ARKANSAS POWER & LIGHT COMPANY

SUBJECT: Arkansas Nuclear One - Unit 1
Docket No. 50-313
License No. DPR-51
ANO-1 Reactor Coolant Pump Inservice
Inspection Relief Request

FIGURE 1

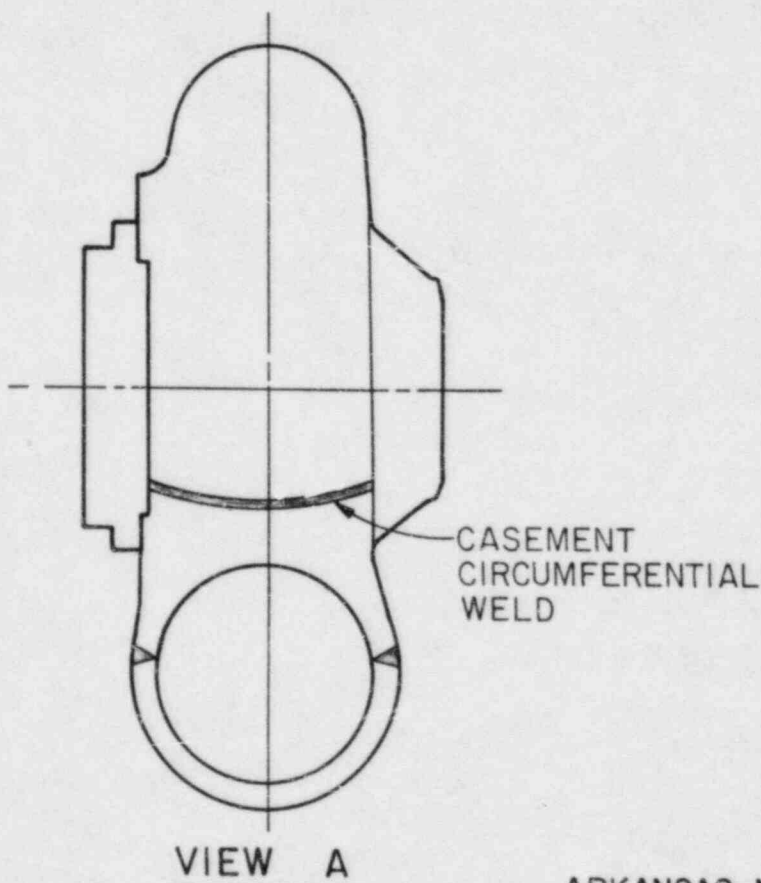
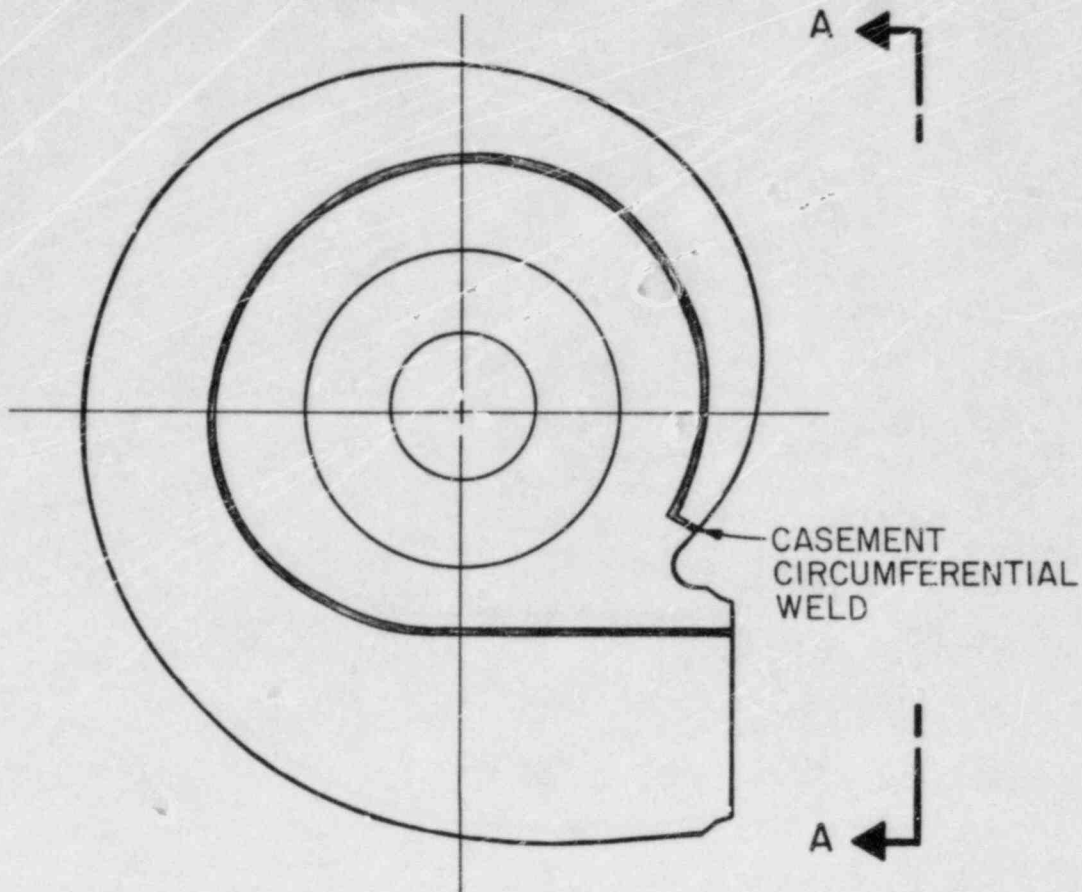
experience with the use of the MINAC system on a Byron-Jackson pump, based on AP&L's confidence in the performance of the system and desire to comply with code requirements, AP&L chose not to pursue relief request relative to this item. Following receipt of the MINAC and removal of the RCP insulation in preparation for the examination, it was discovered that portions of the RCP casing weld will not be accessible for inspection. This is primarily due to the configuration of the casing circumferential weld (see attached Figure 1). Due to interferences and the amount of intervening material, the vertical portion of the weld cannot be examined using the MINAC system.

AP&L is currently proceeding with the scheduled inspection and expects to be able to examine approximately ninety-five percent of the pump casing weld volume. However, since this will not completely meet the code requirements, relief is requested in accordance with 10 CFR 50.55a (g). Also included is a related relief request from the requirement for visual examination of the pump casing internal surface. Although the impracticality of pump disassembly has been the subject of previous correspondence, this correspondence concentrated on the volumetric examination of the casing welds. AP&L has investigated alternate inspection techniques such as fiberoptics, etc., but has concluded that no means other than the partial replication exam obtainable with the MINAC system is practical.
